NORTHEAST UTILITIES

November 12, 1992

Millstone Nuclear Power Station, Unit No. 3
Temporary Heating Source--Operability of the Charging Pump
Proposed Changes to Technical Specifications

Safety Assessment of the
Installation of Temporary Heaters in
the CHS/CCP Areas of the Auxiliary Building

FIGURE 1

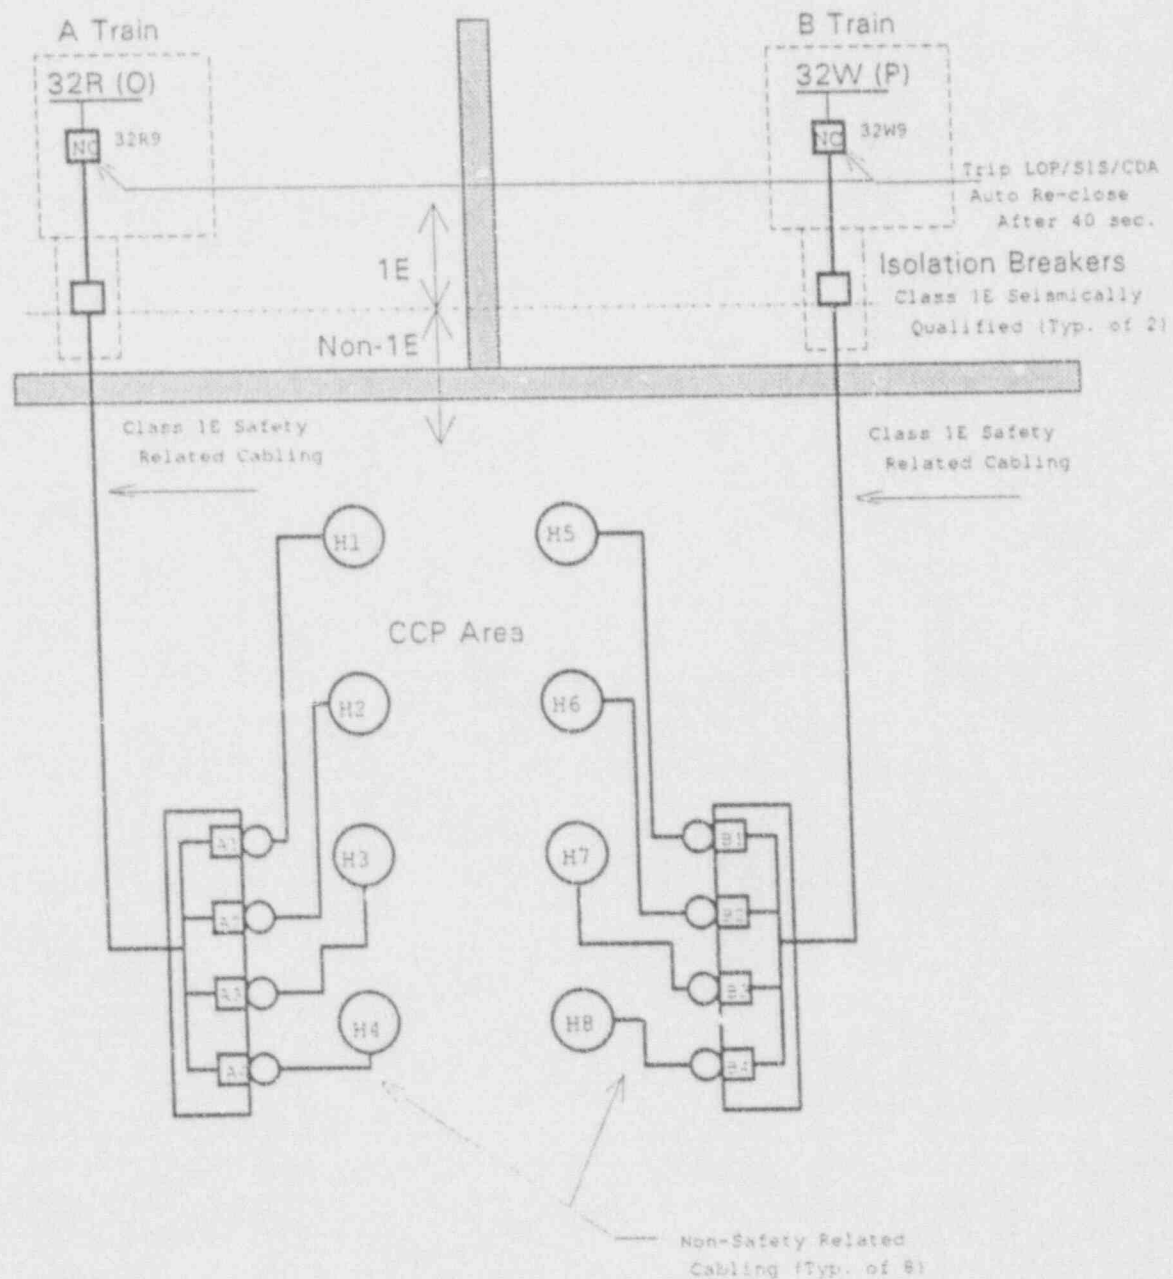
In a letter dated November 12, 1992, NNECO informed the NRC Staff of the status and planned course of action taken for the resolution of the design deficiencies related to the auxiliary building ventilation system (ABVS). Several design changes made to the auxiliary building ventilation system (ABVS) may prevent it from controlling the temperature in the auxiliary building. Five local space heaters have been installed in the charging pump (CHS)/the reactor plant component cooling water pump (CCP) areas of the auxiliary building to maintain building ambient at 65°F. However, because these local heaters are powered from nonemergency power sources, this heat would not be available during a Loss of Power (LOP) when only the Emergency Diesel Generators are supplying AC power. The purpose of this design modification is to change the power sources to these heaters such that the heaters will be available during a LOP. Three additional space heaters powered from emergency buses will also be installed under this design modification. See Figure 1 showing an electrical one line of the arrangement of the eight space heaters.

To assure minimum temperature is maintained during a LOP, the local heaters originally powered from nonemergency power sources, will be repowered from emergency buses that receive power from the Emergency Generators (EDG's) during a LOP. Assuming no single failures, the eight unit heaters are sufficient to maintain 65°F in the Aux. Bldg. CHS/CCP Areas during a LOP with an accident. Assuming the loss of one train leaves four units heaters available, four units are sufficient to maintain temperatures greater than 32°F in the auxiliary building CHS/CCP Areas with an outside ambient temperature of 0°F. The heaters have been sized (under normal and minimum voltage conditions) to provide the required heat input under the normal and accident operating conditions.

Each Train of four (4) heaters will be connected through two series Class 1E breakers to an emergency 480V load center bus. The breaker located in the load center (an air circuit breaker-ITE Type K600S) receives a trip signal on a loss of power event. Forty seconds after the Emergency Diesel Generator 4kV supply breaker has closed connecting the EDG to the 4kV bus, the breaker will automatically reclose.

FIGURE 2

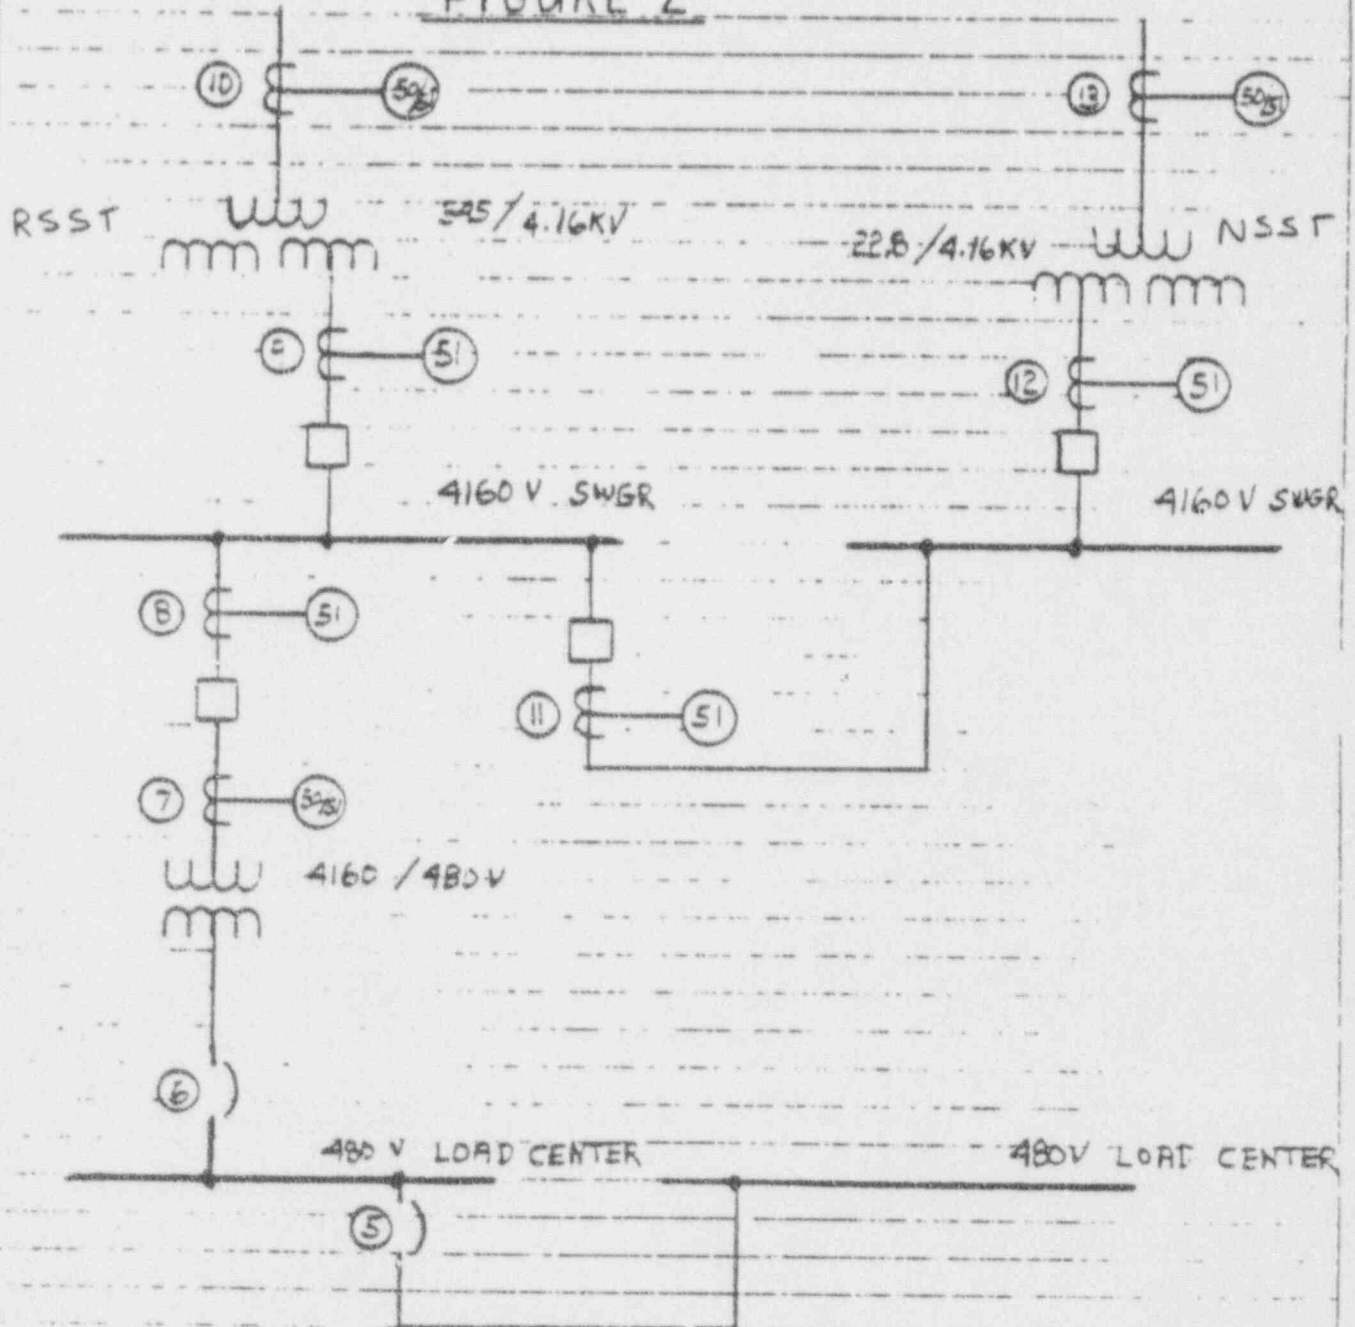
Coordination will be provided such that any size fault on any part of the heater feeder circuit including up to the individual heater, will not result in the loss of the emergency load center. Each of the two series Class 1E breakers will be sized to carry a minimum of 115% of the total heater's full load current. The two series breakers need not be coordinated with each other but are required to coordinate with the bus supply breakers (both the 480V load center incoming breaker and the 4kV supply breaker) and the load center tie breaker. Referring to the attached Figure 2 from the Millstone Unit No. 3 Breaker Coordination Study, these two series breakers will coordinate with the 480V load center supply breaker (breaker no. 6 on Figure 2), the 480V load center tie breaker no. 5 on Figure 2) and the 4kV feeder breaker to the load center (device No.'s 7 & 8 on Figure 2).

The continuous setting for these breakers will be from 175-200 amps @ 480V. Attached for information is Figure 14 taken from the existing Millstone Unit No. 3 Breaker Coordination Study, showing the existing coordination between the bus supply breakers and motor control center supply breakers. Because the heater feeder series breaker will be sized so low in comparison with the bus supply breakers, coordination will not be a concern.

FIGURE 14

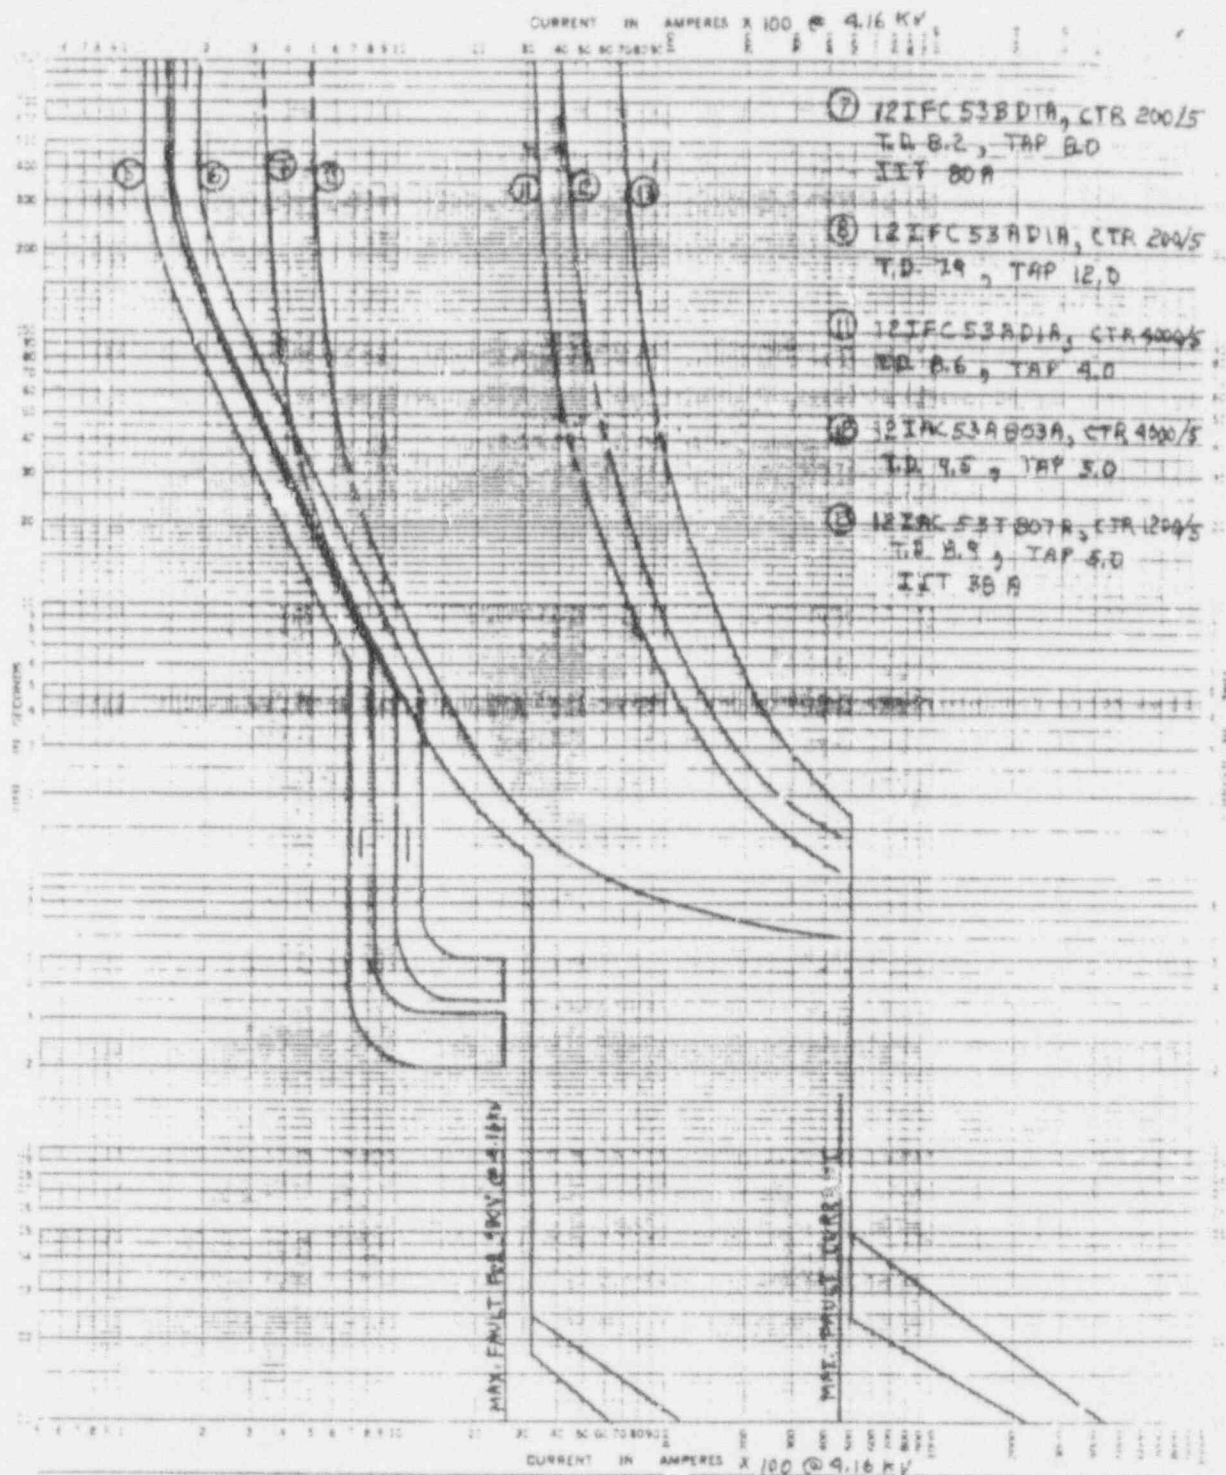
It should be noted that the existing coordination study shows coordination is provided for the 480V load center for much larger loads than these supplementary heaters.
